Docket No. 50-305

Docket No. 50-305

SAFETY EVALUATION REPORT
ON
ECCS EVALUATION MODEL
FOR
WESTINGHOUSE TWO-LOOP PLANTS

SAFETY EVALUATION SUPPORTING CONTINUED SAFE OPERATION
OF WESTINGHOUSE DESIGNED TWO LOOP PLANTS

Figure 5

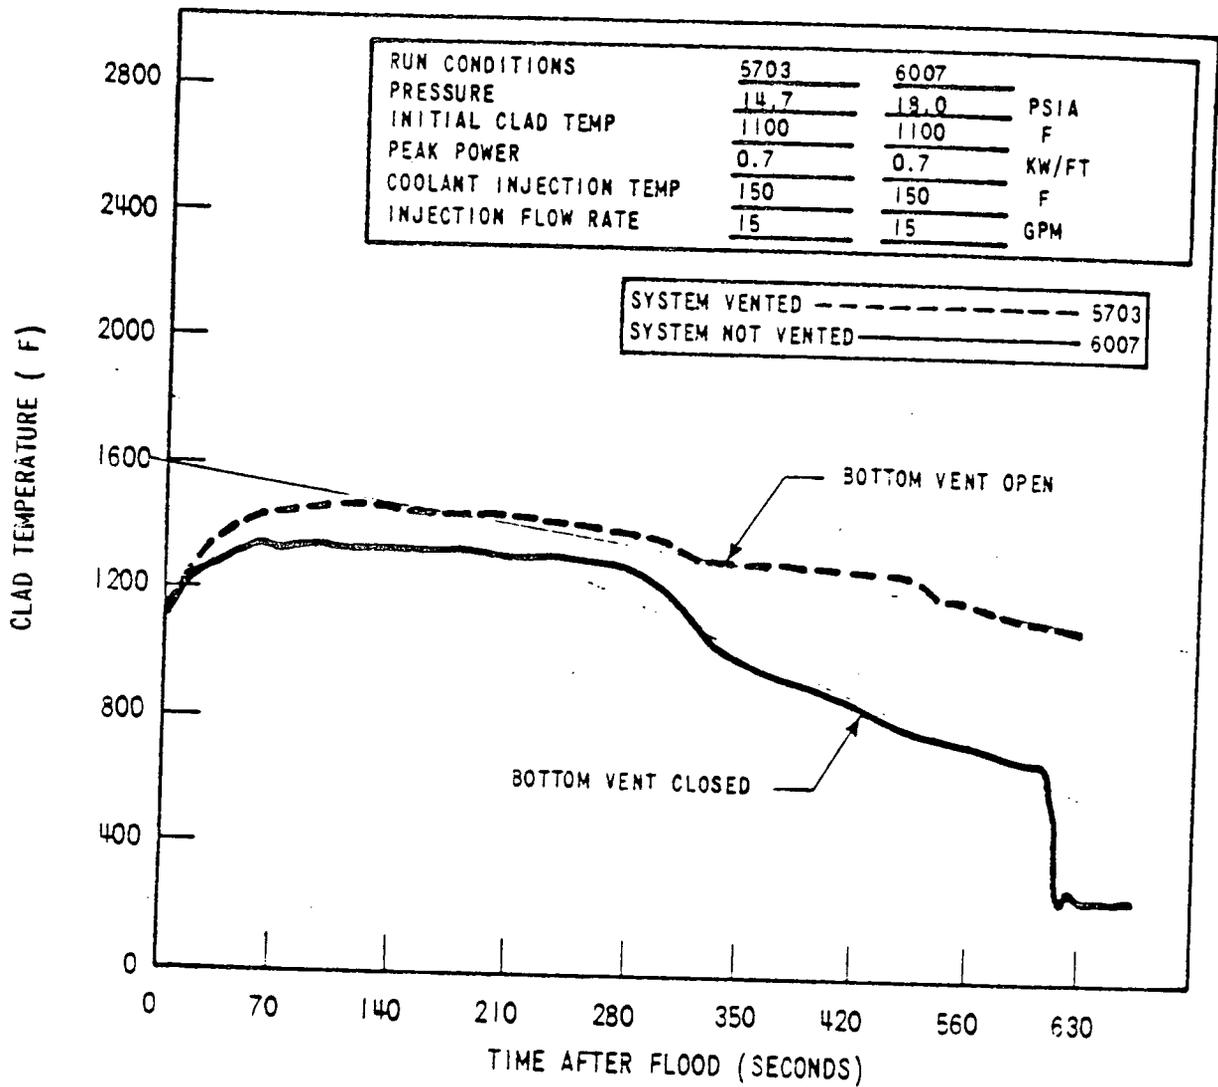
Entrainment increases rapidly as the gas velocities are increased above the critical velocity for the onset of entrainment. This trend is seen in all of the data. A linear fit to the data on Figure 5 was used for entrainment fractions up to .3.

Figure 9

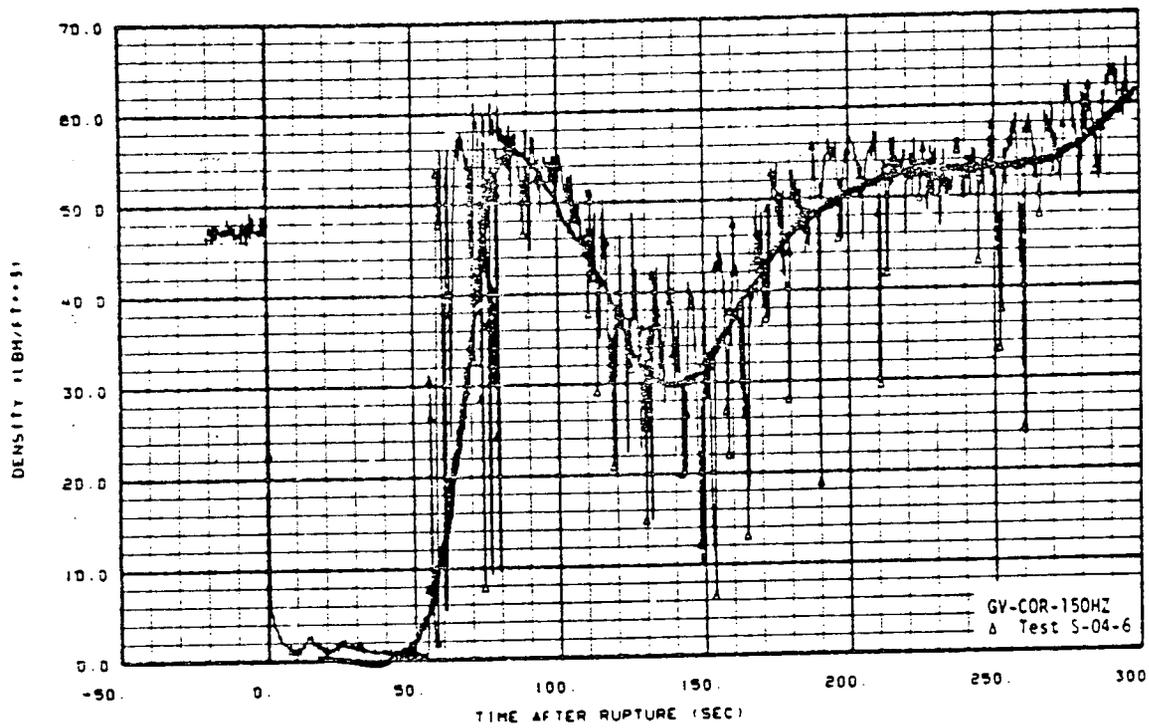
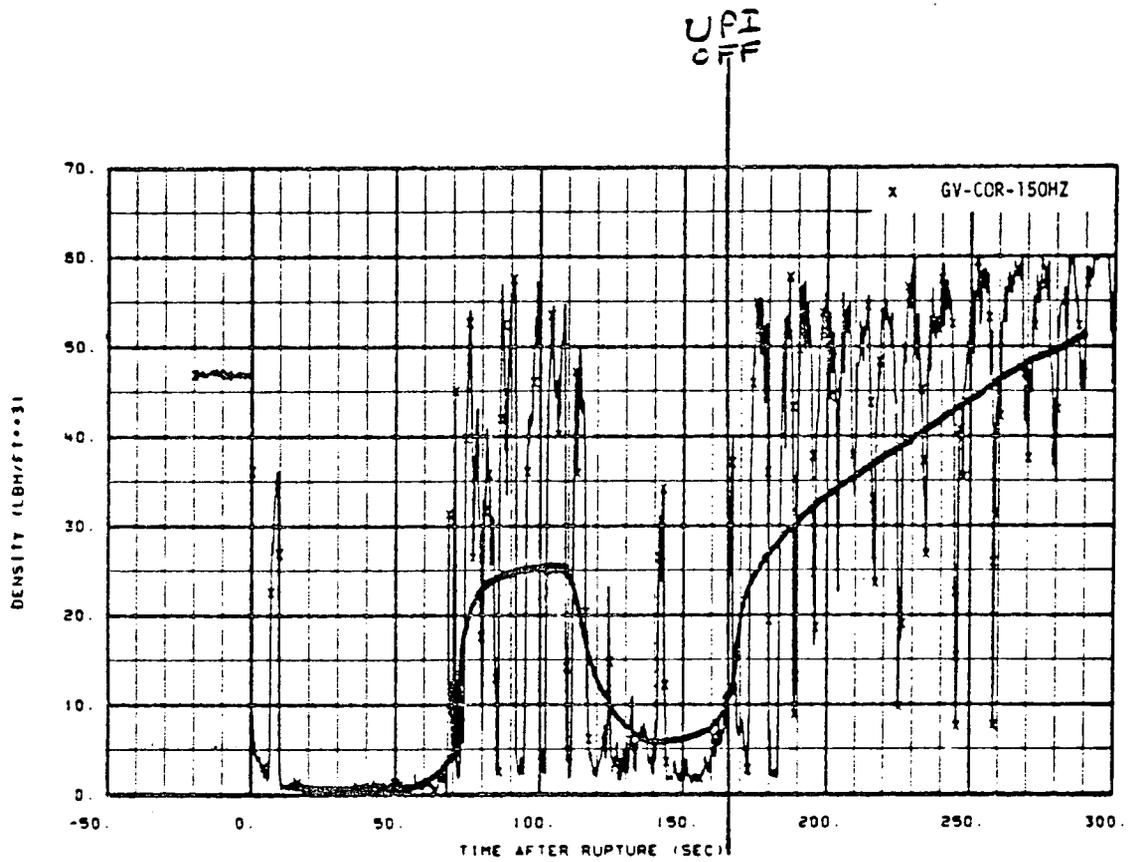
Semiscale tests S05-3 and S-05-4 were both upper plenum injection tests with 16 GPM and 8 GPM, respectively, injected by the vessel accumulator with a pressure setting of 300 PSIA. In each case, the injection period was from approximately 20 seconds to approximately 150 seconds. Because of the need for parametric variation to understand the two-loop, upper plenum injection problems, a third semiscale test was run with low pressure pumped injection into the upper plenum at an injection rate more typical of two-loop plants. In each case the results were similar: UPI water entered the core while cold leg injection was underway but before recovery of the bottom of the core. Steam was generated in the core by vaporization of the UPI water. This steam was drawn to the cold leg injection water which was the low pressure point in the system due to the subcooling of the cold leg ECC water. As a result, the UPI test generally showed increased ECC bypass and little or no reflooding of the core from below. Figures 8 and 10 illustrate the difference in bottom reflooding with and without UPI. Figure 8 shows the density just below the core for test S-04-6, the base case without UPI. After 50 seconds the density remains relatively high with oscillations about an average value which varies from 30 lb/ft^3 to 60 lb/ft^3 . Figure 9 shows that the density at the same location in test S-05-3 oscillates about an average value which varies from 5 lb/ft^3 to 25 lb/ft^3 while UPI injection continues. At 164 seconds UPI terminated in this test and Figure 9 shows an almost instantaneous

increase from 10 lb/ft³ and a continuing trend of increasing density thereafter. The general trend of poor bottom reflooding persists throughout each semiscale test. This is also shown in Figure 10 which illustrates the volumetric flow rate at the core inlet. This figure clearly indicates negative flow at the core inlet until the end of UPI at which time the volumetric flow rate oscillates around zero.

Figure 19

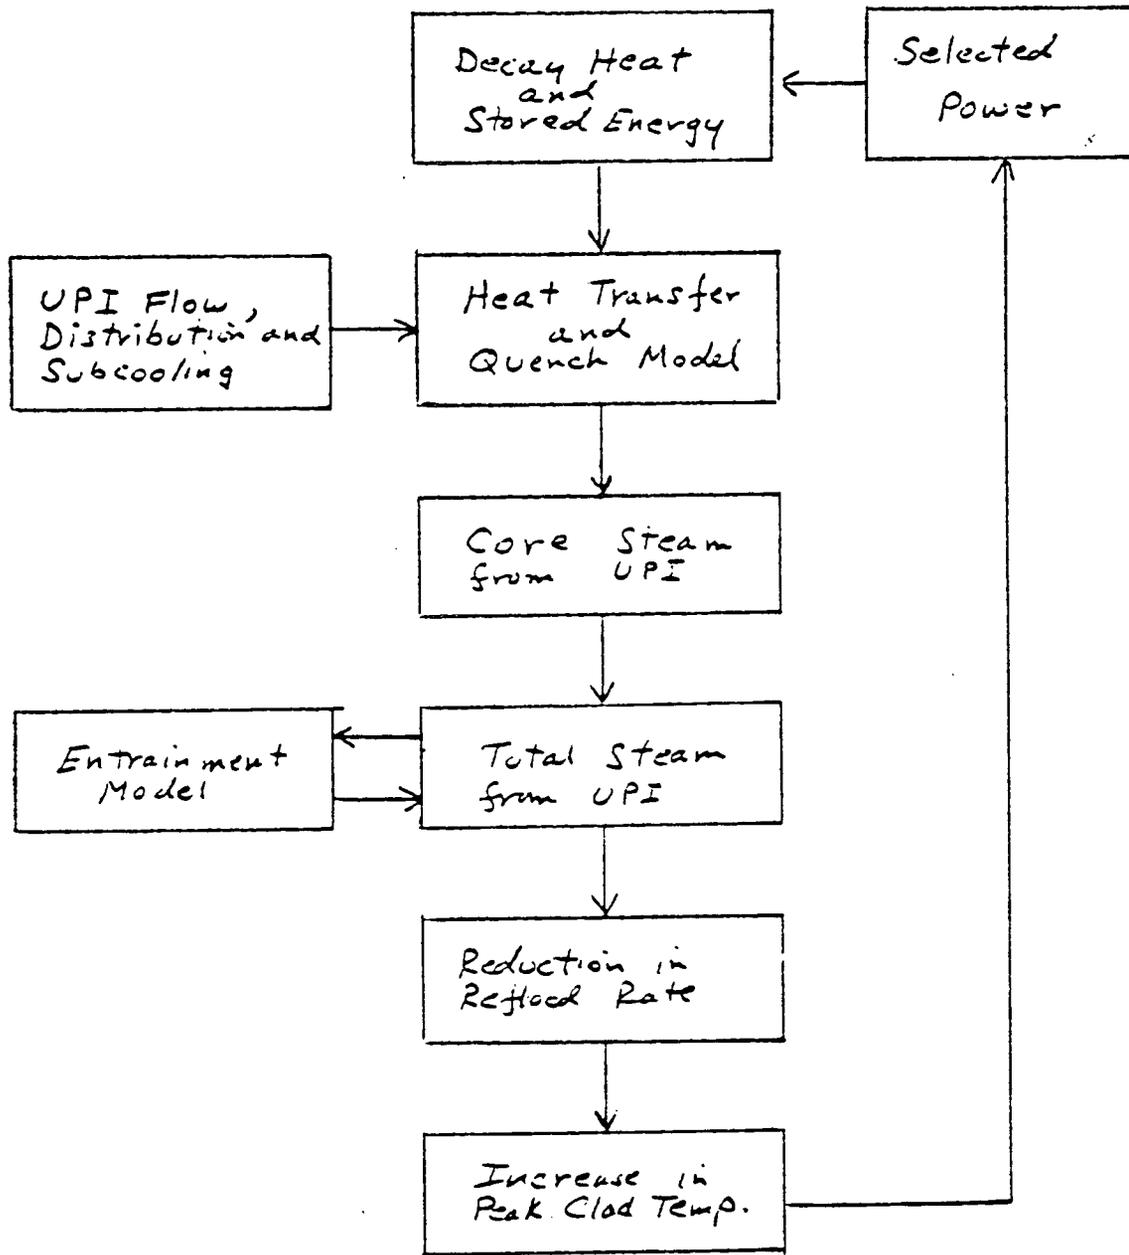
The elements of the staff model and their interactions are shown in Figure 19. The procedure used in this model is summarized in the following steps, where each step is performed as a function of initial power level:

1. Establish an upper plenum flow rate, subcooling and flow distribution.
2. Determine the decay heat and stored energy in the fuel.
3. Determine the heat transfer and quench rate from the upper plenum injection flow.
4. Determine the amount of vaporization of upper plenum injection water by the heat added to the water and the initial subcooling of the water.
5. Determine the entrainment of upper plenum injection water by calculating - the momentum flux of steam and water exiting the core and then finding the corresponding entrainment fraction from a correlation of entrainment fraction vs. modified momentum flux.

Figure 23

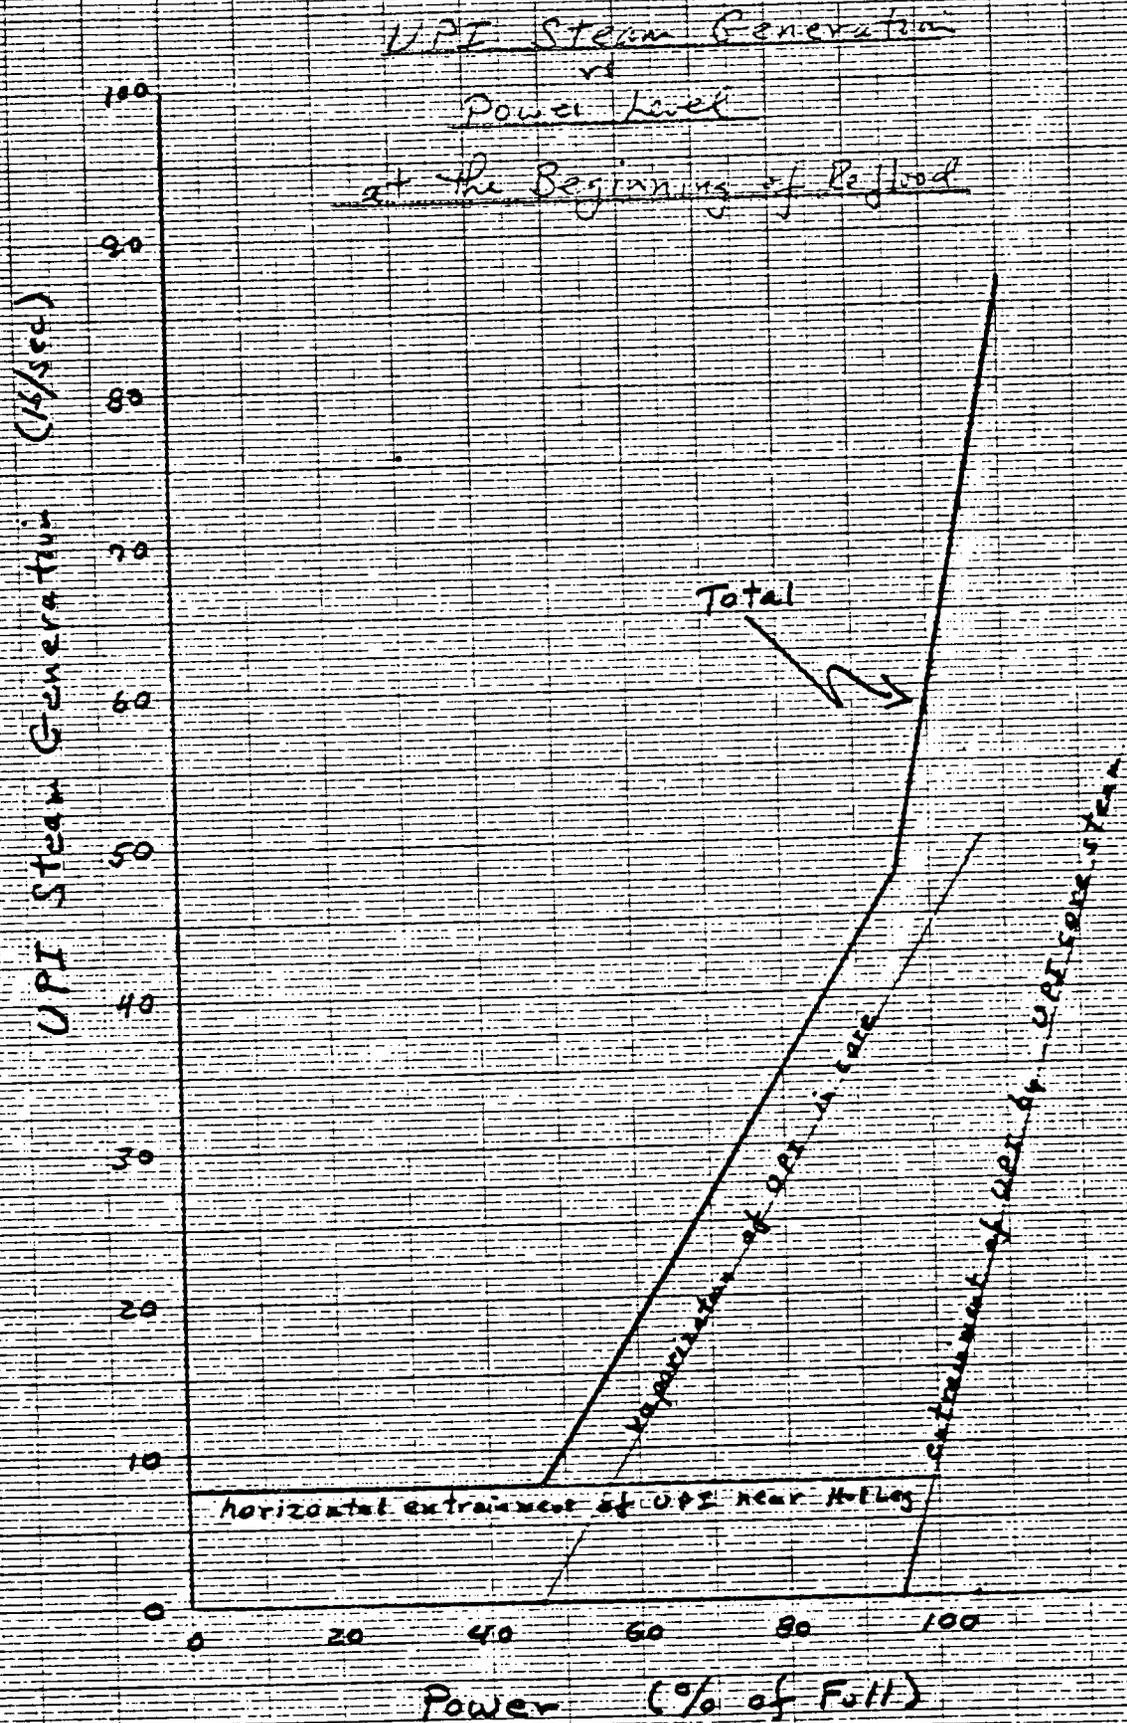
plenum injection water by the core steam (due to upper plenum injection vaporization) exiting the core. Figure 23 presents each of these components and the total steam generation as a function of initial core power level at a point in time near the beginning of reflood.

Figure 25

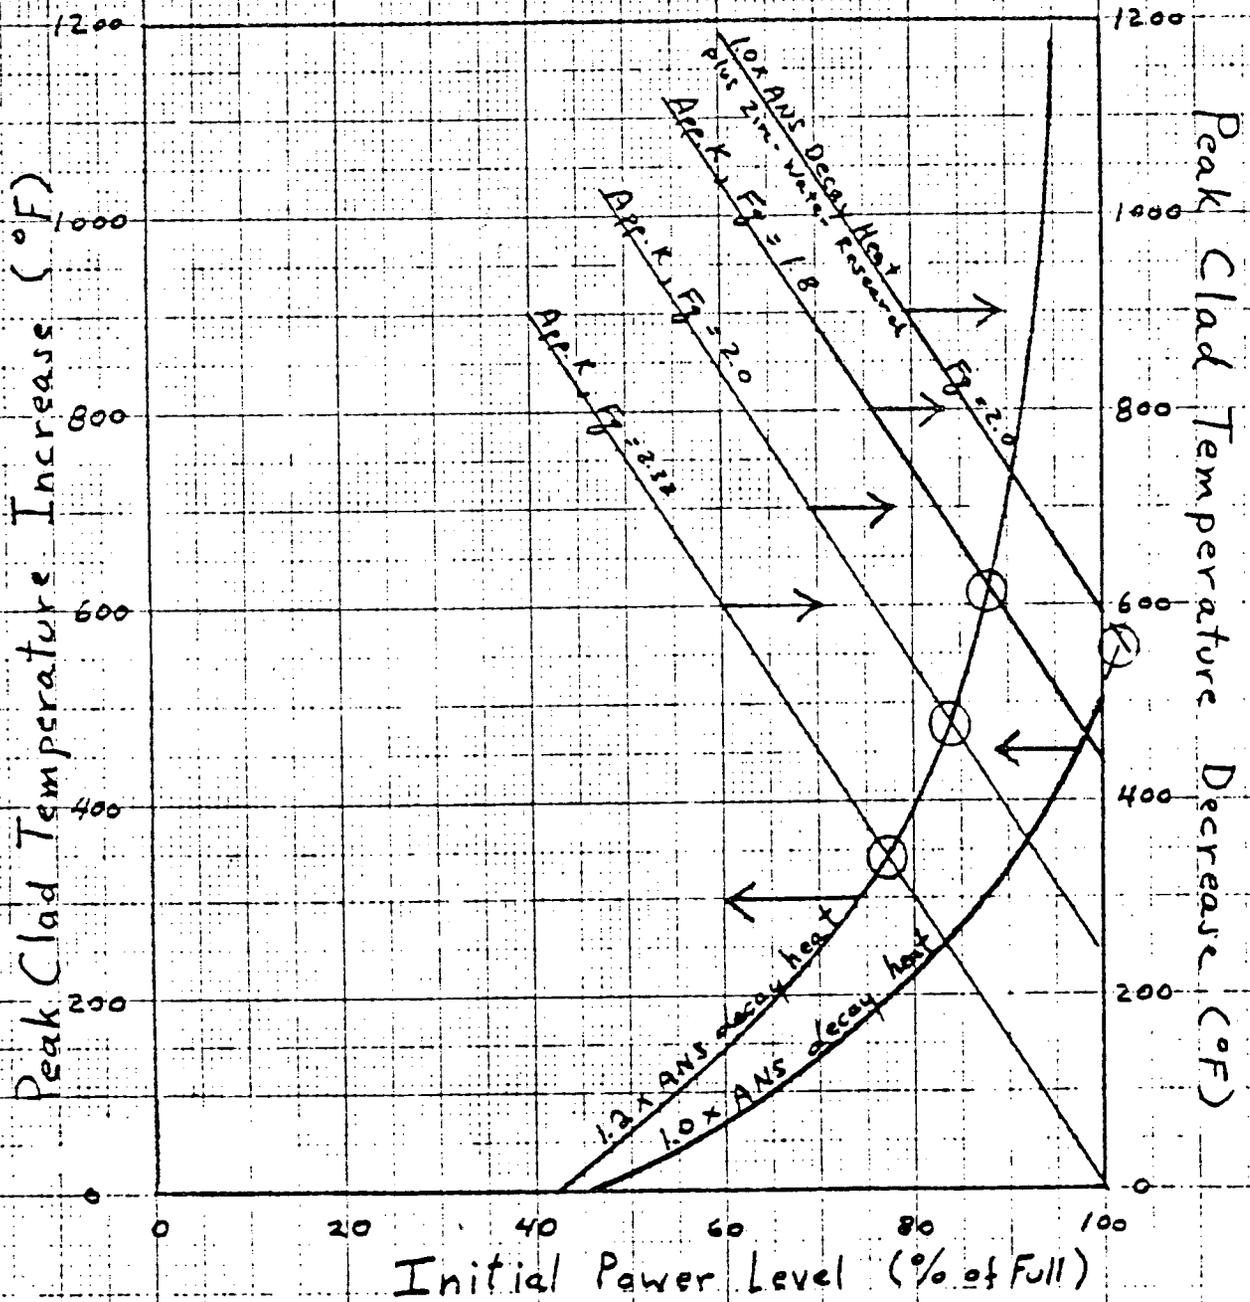
The staff model assesses a penalty on peak clad temperature to account for the generation of steam due to upper plenum injection. Figure 25 presents the peak clad temperature penalty as a function of initial power level. At approximately 50% power, the heat being removed from the core can no longer be absorbed completely by the initial subcooling of the upper plenum injection water and the result of steam generation in the core can be seen in the figure. At 92% power, entrainment of upper plenum injection water begins and the penalty on peak clad temperature increases rapidly. This rapid increase is a reflection of the rapid increase in entrainment which occurs after the onset of entrainment.
